Wisconsin Electric POWER COMPANY
231 W. MICHIGAN, P.O. BOX 2046, MILWAUKEE, WI 53201

January 3, 1985

DOCKET NOS. 50-266 AND 50-301
APPENDIX R EXEMPTION REQUESTS
POINT BEACH NUCLEAR PLANT UNITS 1 AND 2

On June 30, 1982, Wisconsin Electric Power Company requested the following exemption for the 4160V switchgear room at the Point Beach Nuclear Plant:

4160V SWITCHGEAR ROOM
SAFE SHUTDOWN CABINET
LOCATION

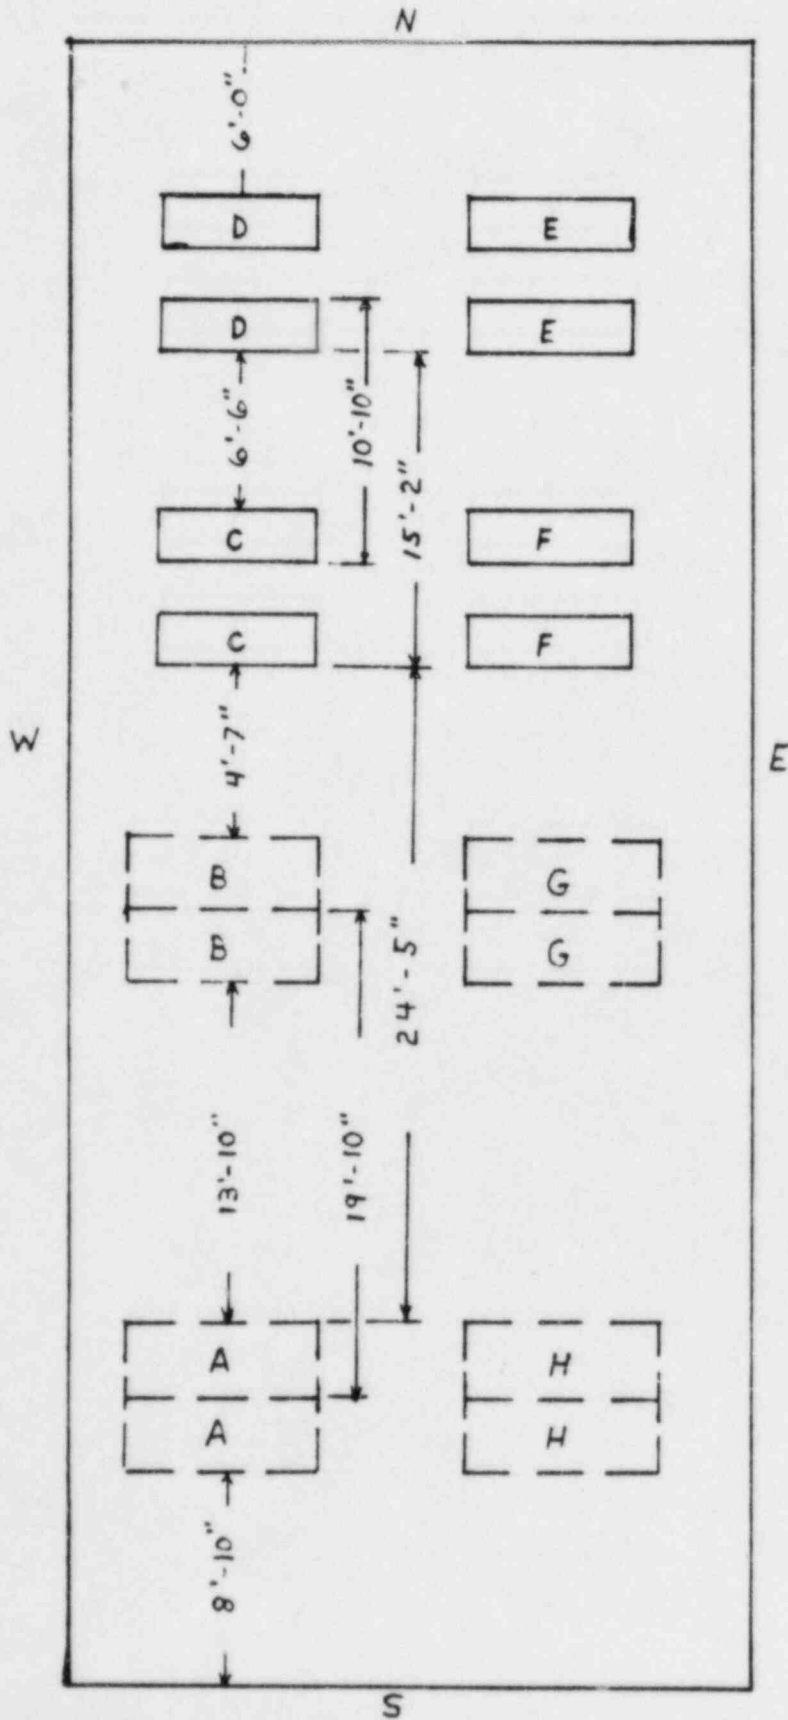
- o SAFETY RELATED 4160 V_{AC} SGR AT NORTH END
- o NON-SAFETY RELATED 4160 V_{AC} SGR AT SOUTH END
- o EITHER CAN PROVIDE POWER TO REQUIRED 480 V_{AC} SWITCHGEAR
- o FIRE EFFECTS ON ONE HALF SWITCHGEAR ROOM WOULD NOT PRECLUDE
SAFE SHUTDOWN
- o EXISTING HORIZONTAL SEPARATION MEETS SECTION III.G.2.B

SMOKE AND HEAT DETECTOR LOCATION SWITCHGEAR ROOM

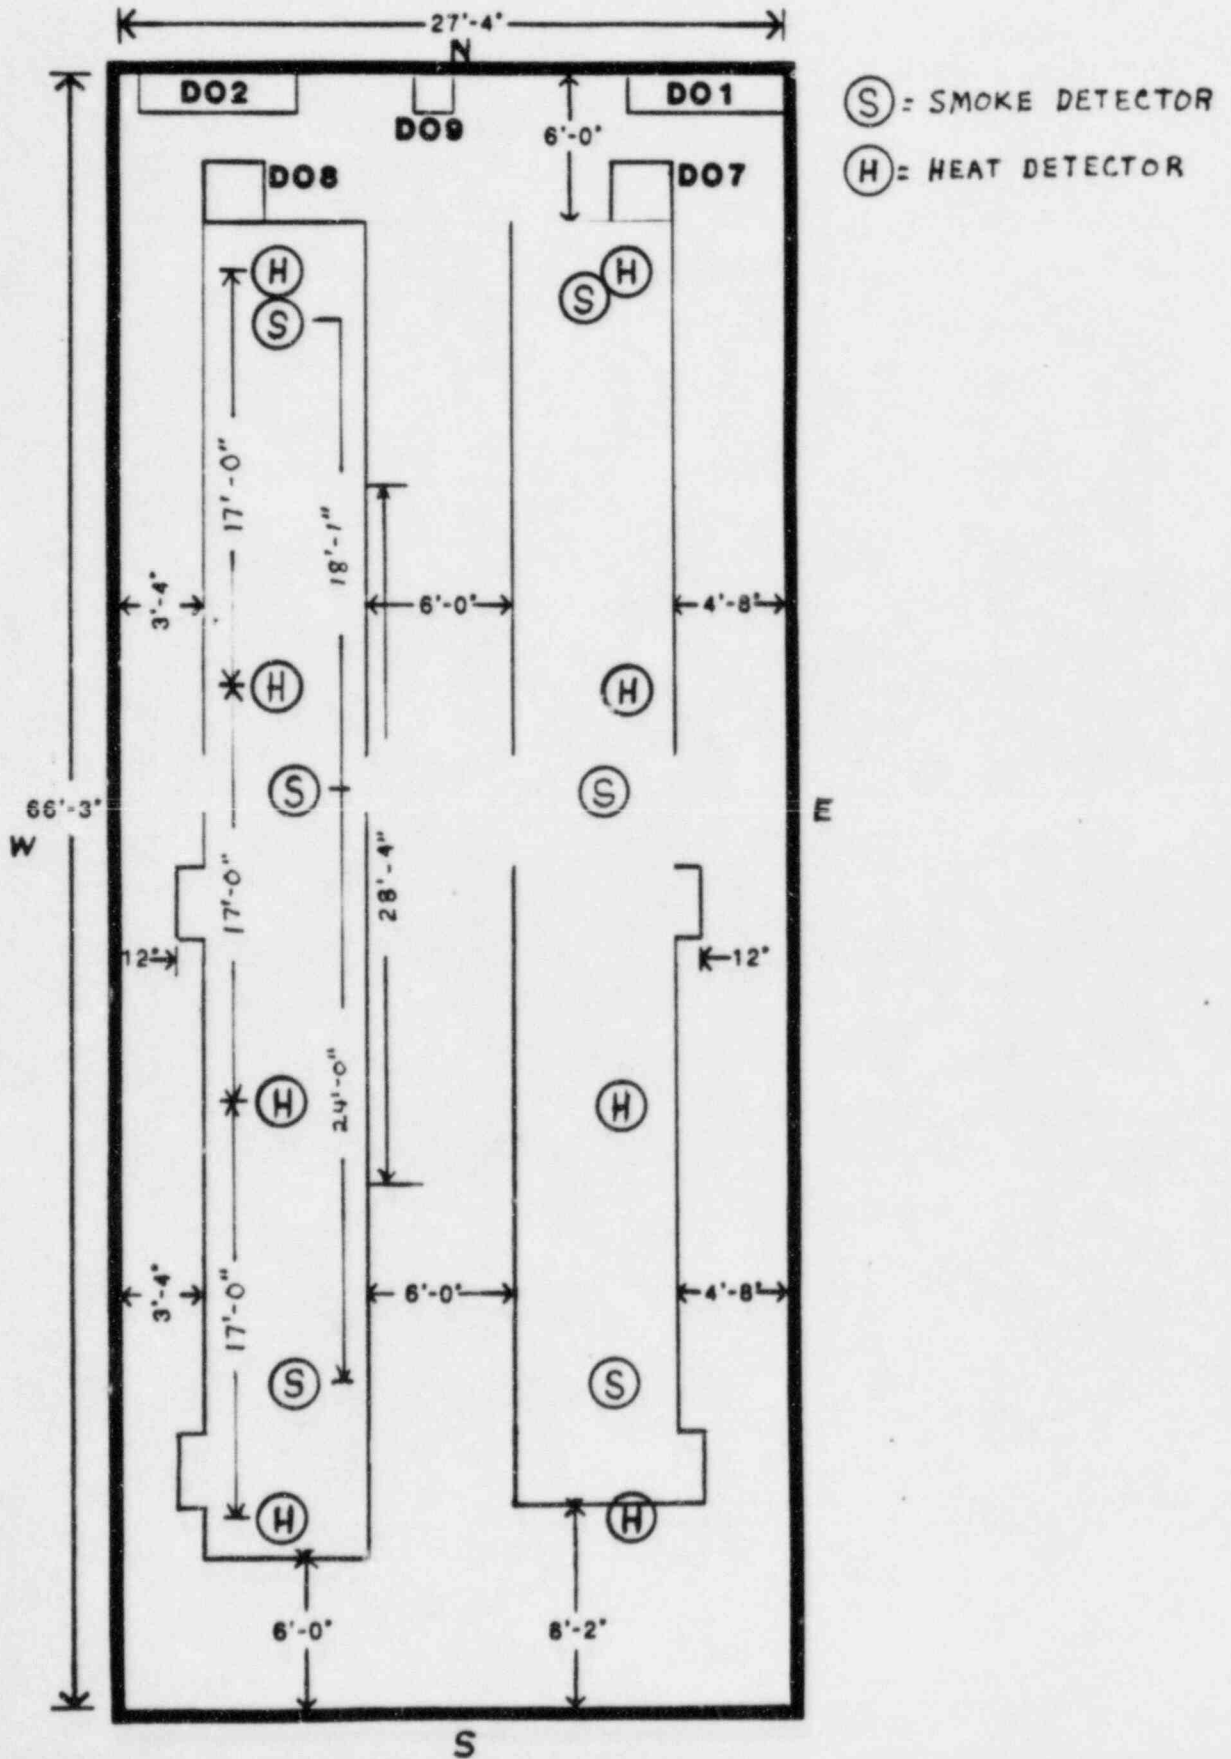
- o CONFORMS TO NFPA 72D & 72E
- o REDUNDANT AND DIVERSE ACTIVATION
- o DETECTOR PLACEMENT BASIS IN EXCESS OF NFPA 72E
- o SMOKE DETECTOR PLACEMENT ACCEPTANCE BY BROOKHAVEN NATIONAL LABORATORIES
 - INDEPTH REVIEW BY DR. BOCCIO OF BNL
 - MARCH 3, 1980 & MARCH 30, 1980
- o HEAT DETECTOR SPACING CLOSER THAN REQUIRED BY FACTORY MUTUAL APPROVAL GUIDE

FIGURE 5
SERVICE WATER PUMP CABLES

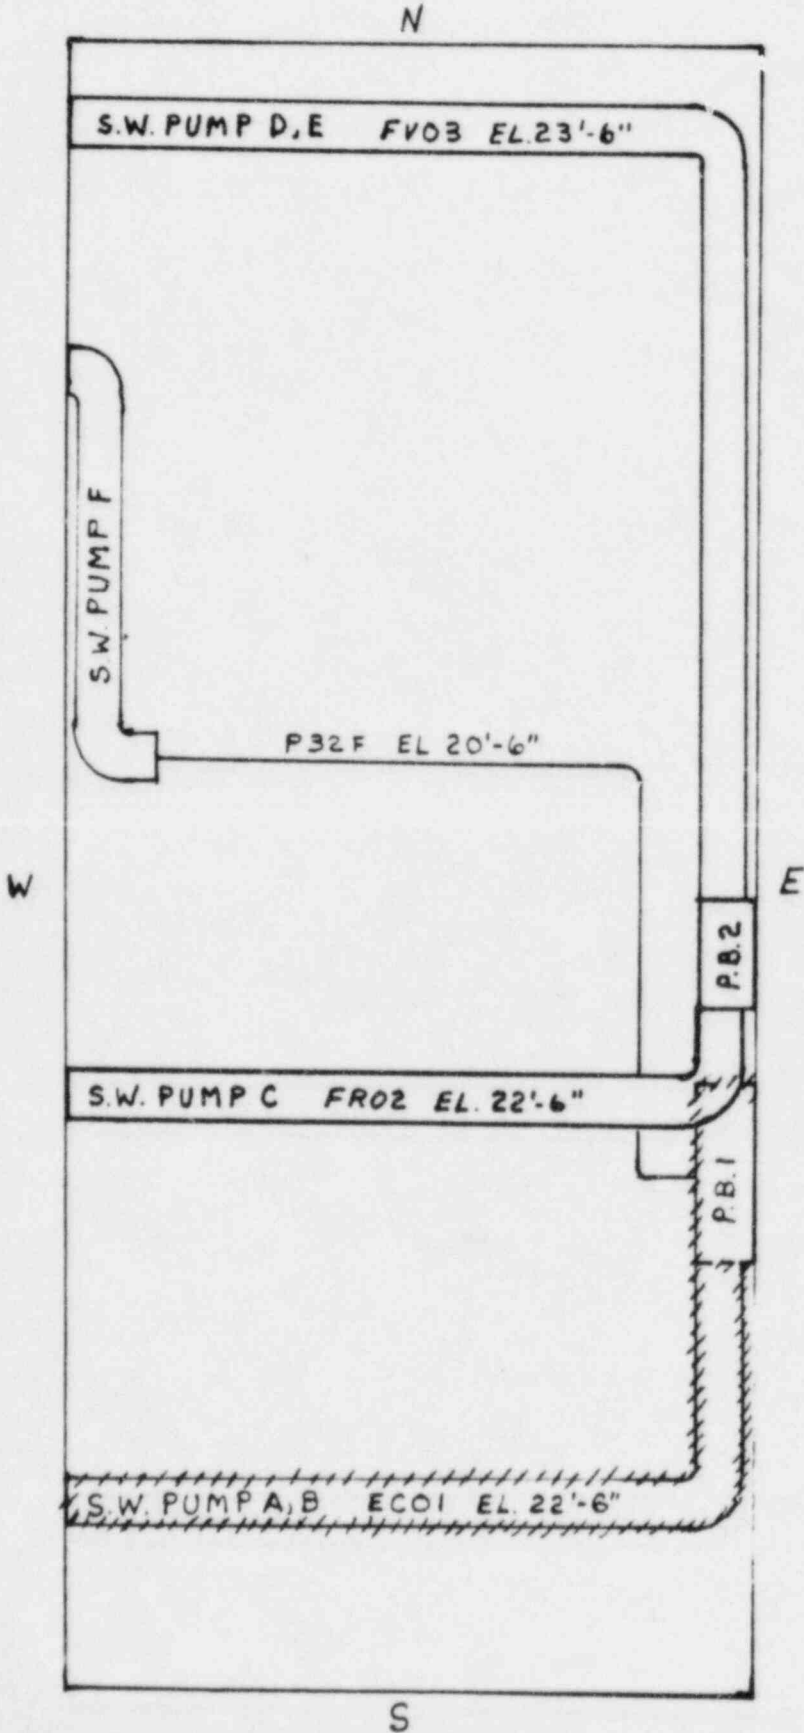
8. Provision of cable tray wrapping and pullbox enclosure of power cables for two service water pumps which are necessary to achieve safe shutdown.
9. Provision of wrapping of cable trays which contain incoming and outgoing non-safeguards power cables for one alternate set of switchgear which can be used to accomplish safe shutdown.

4160V SWITCHGEAR ROOM
POWER SUPPLY CABLE
LOCATION

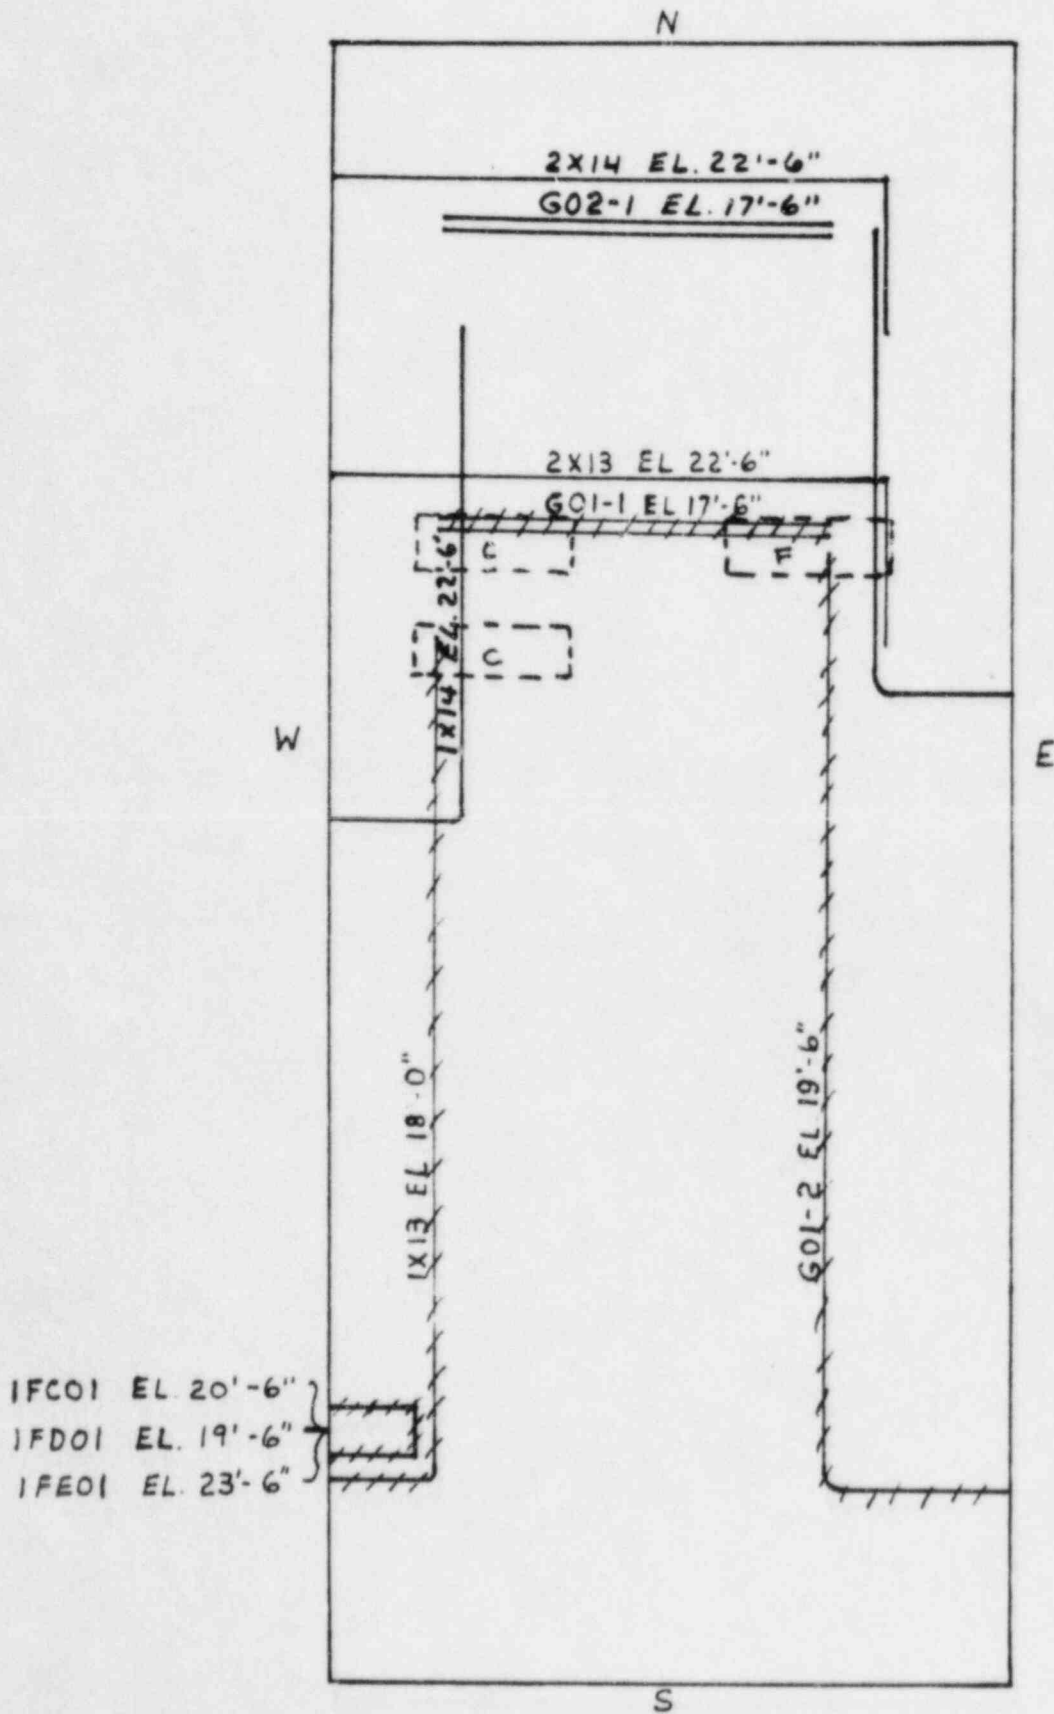
6. Provision of wrapping for conduit within the room which contains one division of incoming safeguards power cable from one diesel generator.
7. Provision of wrapping for conduit within the room which contains one division of outgoing safeguards power cable necessary to power required safe shutdown equipment.
